# ESCAPE HAMMER AND BUZZER

## ■ GENERAL

04Z6BO04Z

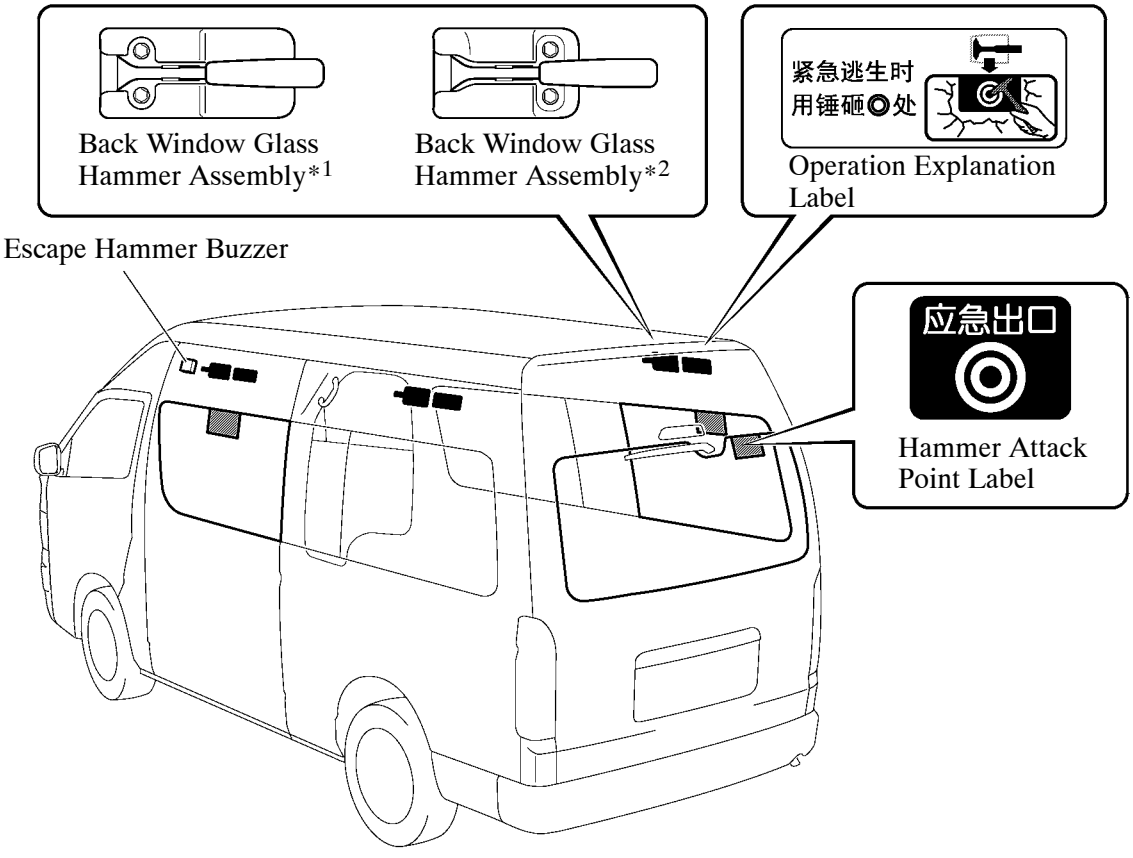
- The shape of the back window glass hammer assembly has been changed for the China package. A switch for activating the escape hammer buzzer has also been installed in the back window glass hammer assembly.

- The set number of back window glass hammer assemblies has been changed from one to three for the China package.
- An escape hammer buzzer has been adopted for the China package. If even one of the three back window glass hammer assemblies is removed, the switch installed in the back window glass hammer assembly will turn on, and the escape hammer buzzer installed in the roof side part will sound.

- Labels that read “Emergency Exit” and indicate the hammer attack point have been affixed to the emergency escape window for the China package. A label that instructs how to operate the back window glass hammer assembly has also been affixed to the roof near the location of the back window glass hammer assembly.
